# Wisconsin Department of Transportation

**Proposal #26: 8180-02-70, WISC 2015 018**  
**Ladysmith - Ojibwa**  
**Thornapple River Bridge B-54-0120**  
**STH 27**  
**Rusk County**

This is Addendum No. 01, which provides for the following:

**ADDENDUM NO. 01**

Addendum No. 01  
ID 8180-02-70  
Revised Sheet 3  
December 1, 2015

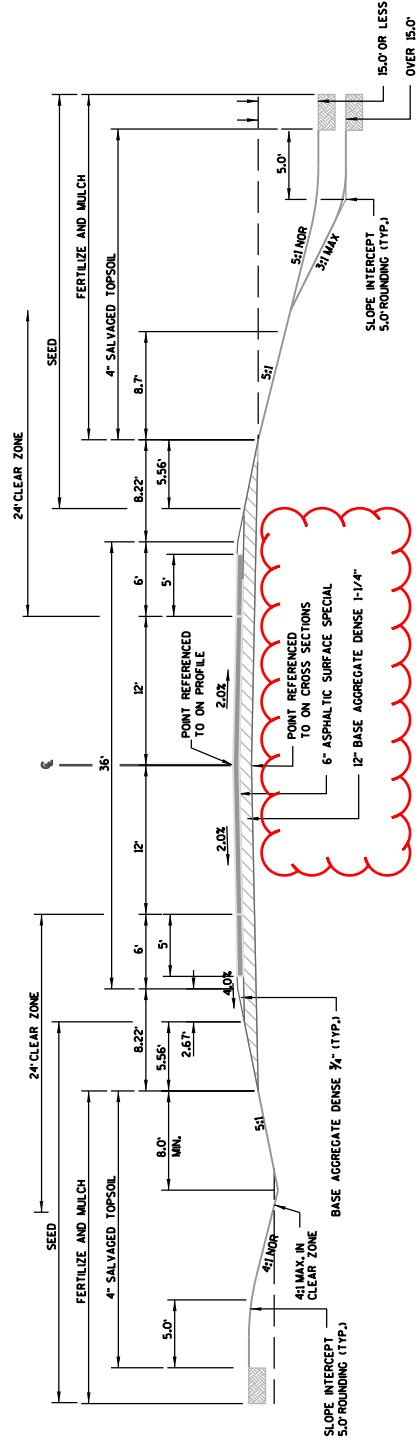
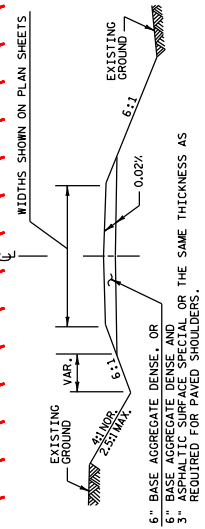
Revised Plan Sheets	
Plan Sheet	Plan Sheet Title (brief description of changes to sheet)
2	General Notes (Changed HMA Pavement to Asphaltic Surface Special)
3	Typical Sections (Changed HMA Pavement to Asphaltic Surface Special)
4	Construction Details (Changed HMA Pavement to Asphaltic Surface Special)
